From: Hamlet, Robert, EMNRD
Sent: Tuesday, April 14, 2020 4:05 PM
To: 'Liz Klein'
Cc: Natalie Gordon; Bratcher, Mike, EMNRD; Venegas, Victoria, EMNRD; Eads, Cristina, EMNRD
Subject: RE: Closure-Deferral Denied - 3 Bear - Dark Canyon (Carlsbad 960 SWD) (Incident #NAB1929160071) (2RP-5675)

From: Hamlet, Robert, EMNRD [<mailto:Robert.Hamlet@state.nm.us>]
Sent: Monday, March 23, 2020 4:26 PM
To: Liz Klein <lklein@3bearllc.com>
Cc: Bratcher, Mike, EMNRD <mike.bratcher@state.nm.us>; Venegas, Victoria, EMNRD <Victoria.Venegas@state.nm.us>; Eads, Cristina, EMNRD <Cristina.Eads@state.nm.us>
Subject: Closure-Deferral Denied - 3 Bear - Dark Canyon (Carlsbad 960 SWD) (Incident #NAB1929160071) (2RP-5675)

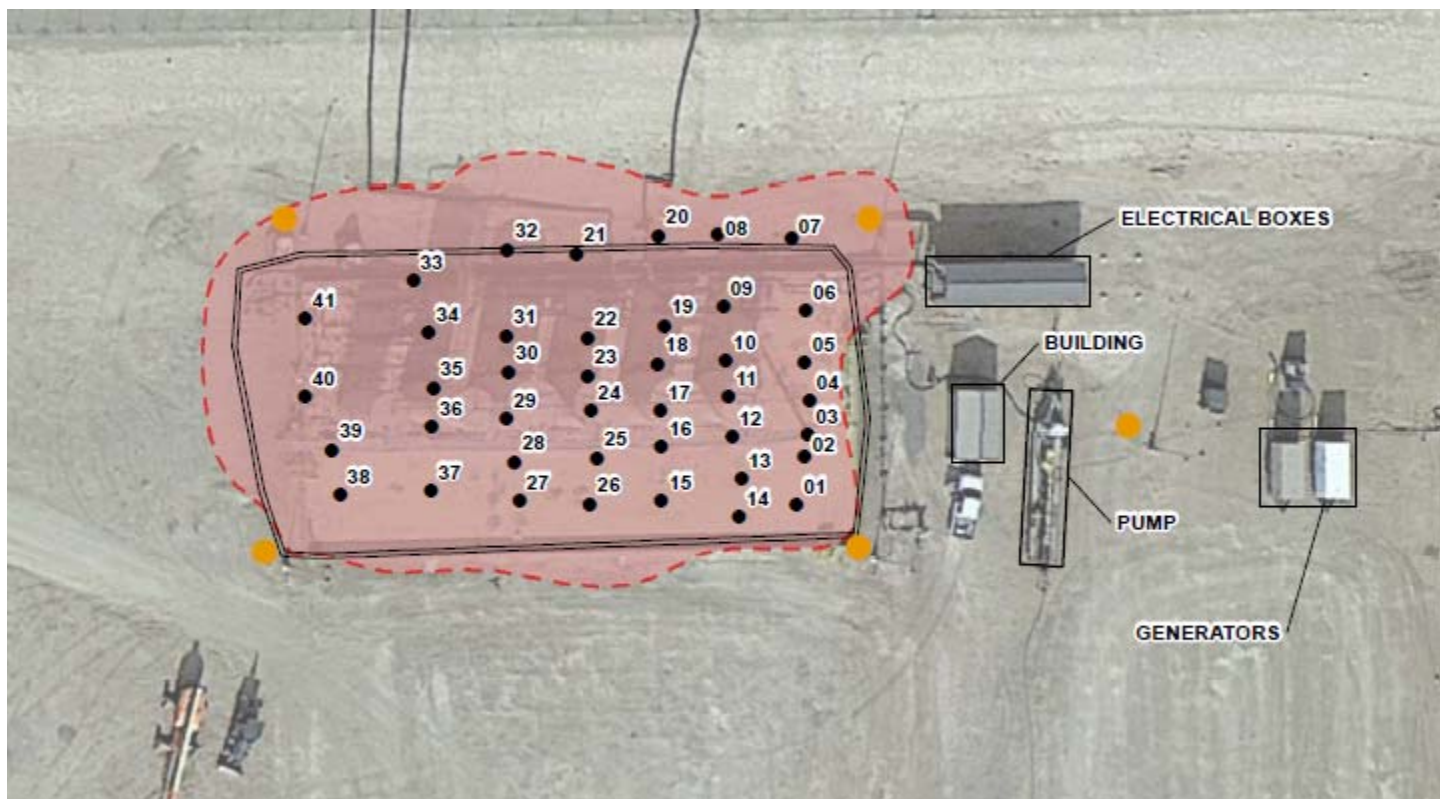
Attached is a map with the original gps sampling points overlaid on a more recent aerial that shows the site fully constructed. The aerial photo that was the background on diagram in the C-141 submittal was an aerial photo from before the site was fully constructed; so it appeared that 4 sample points were off the pad. The four sample points in question are on the pad. I apologize for the confusion. And am requesting a full closure for the incident.

The four points look like they are off the pad or on the lease road and even your own diagram shows that they are outside the boundary of the active pad.

- Soil sample locations BS19-38, BS19-39, BS19-40, and BS19-41 are either on the service road or in the pasture. Both of these locations are considered to be in the pasture/off-pad and need to be delineated to 600 mg/kg for Chlorides and 100 mg/kg for TPH. All off-pad areas must contain a minimum of 4 feet non-waste containing uncontaminated, earthen material.
- Please, complete the delineation/excavation on the 4 soil sample locations in the pasture/off-pad and upload the updated deferral request including signed/dated C-141 Page 5 to the Payment Portal upon completion.

- Please explain the issue with the site map on the first report and that it was an aerial phot from before the site was fully constructed and that the 4 sample points in question were off the pad. A more recent photo shows that they are on the pad.
